## **Eco Park Revised Scheme: FGRFC Stadium, Eastington**

Comments on Planning Application  
S.16/0043/OUT, concerning Transportation  
Matters.

**Doc. No. 1606REP03**

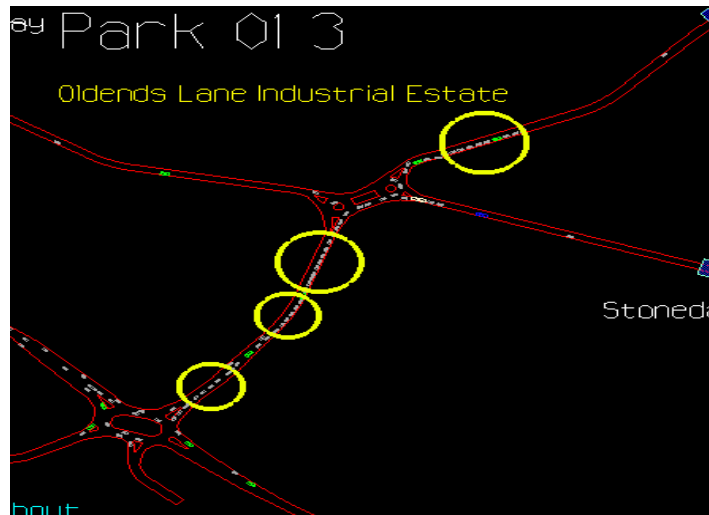
- 3.6.6 The following snapshot, from the PFA micro simulation model, shows a very long queue from the Stroudwater Business Park. Under the circumstances diversions between Chipmans Platt and the B4008 seem inevitable.

- 3.6.7 This report considers the Oldends lane link to the B4008 to be a key, and yet highly sensitive, component to the operation of the existing employment and the WoS allocation site. The absence of this route renders the analysis incomplete.
